SUBJECT: Wake County; Division 5; Construction of the Northern Wake  
Expressway (I-540) from US 1 to US 64; State Project No. 8.2401701;  
TIP Project No. R-2000 F&G

Attached is the modification to WQC Project No. 030114.

Re: Modification to the 401 Water Quality Certification Pursuant to Section 401 of the Federal Clean Water Act, Construction of the Northern Wake Expressway (I-540) from US 1 to US 64 in Wake County. TIP-R2000 F&G, WQC Project No. 030114 (DWQ No. for original application 960319)

**Modification of APPROVAL OF 401 Water Quality Certification and ADDITIONAL CONDITIONS  
and Neuse River Buffer Rules**

# PLAN VIEW SITE 14

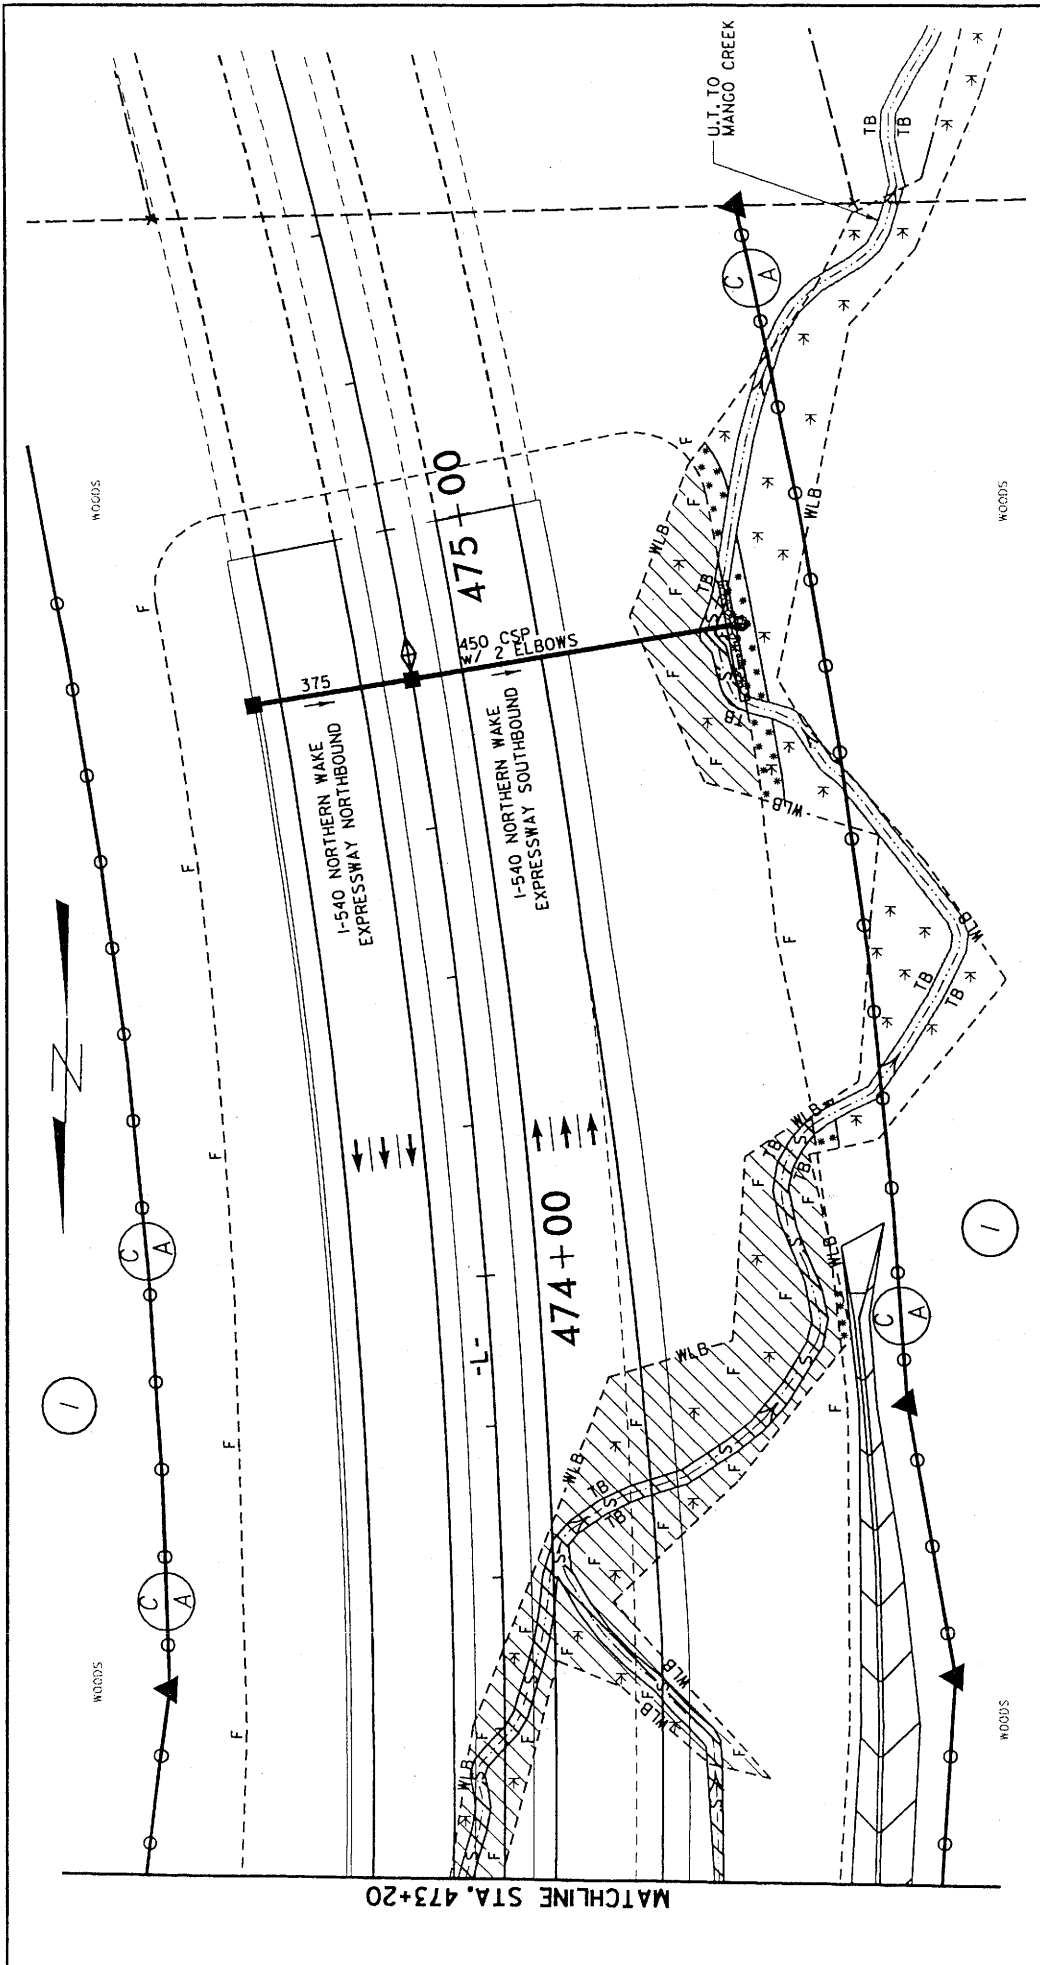
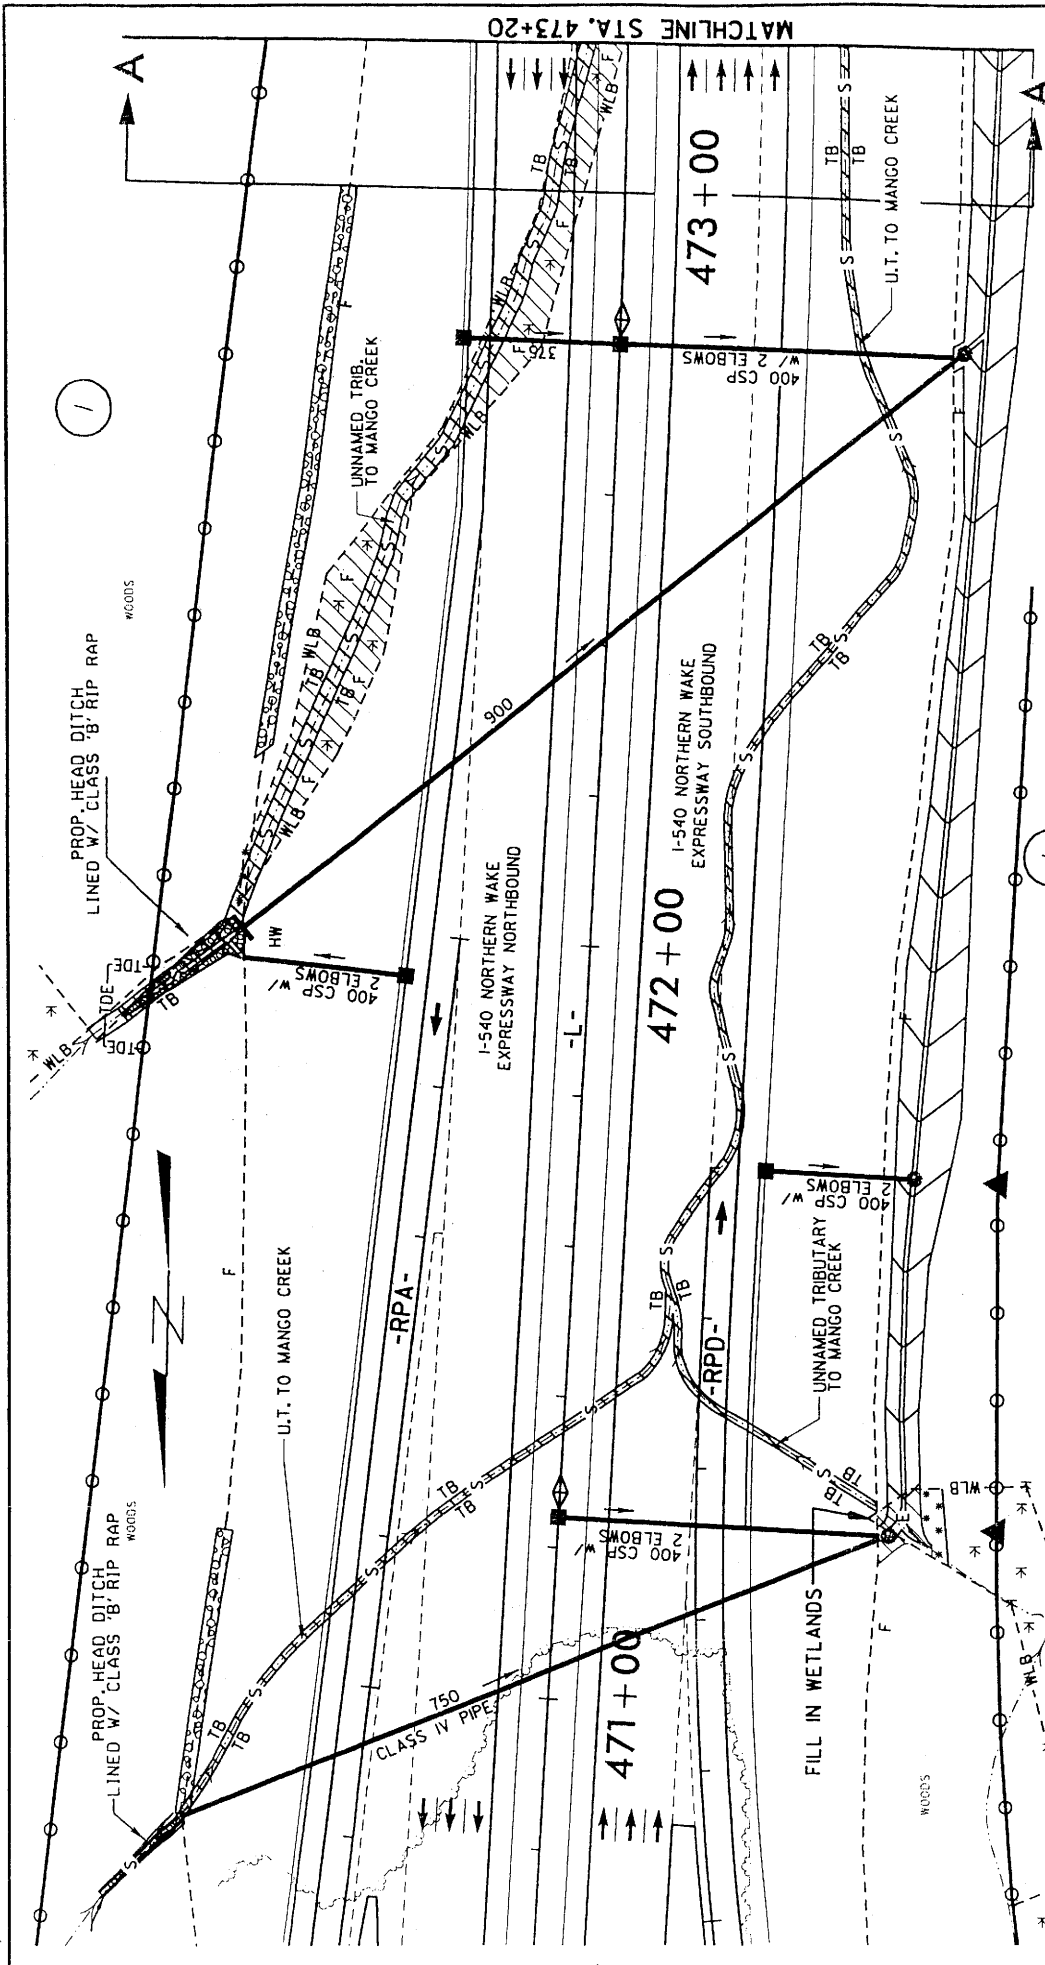
This modification also approves the latest design changes submitted on October 27, 2004 and November 4, 2004, specifically adjustments to the lateral base ditch at Site 14 and a pipe shift at Site 2. This certification modifies only segments F & G of the construction of the Northern Wake Expressway (I-540) from US 1 to US 64 in Wake County and shall be constructed pursuant to the application dated received on September 28, 2004 and supplemental information dated received on October 27, 2004 and November 4, 2004. All the authorized activities and conditions of the certification associated with the original Water Quality Certification dated September 17, 1996 and all subsequent modifications still apply except where superceded by this certification.
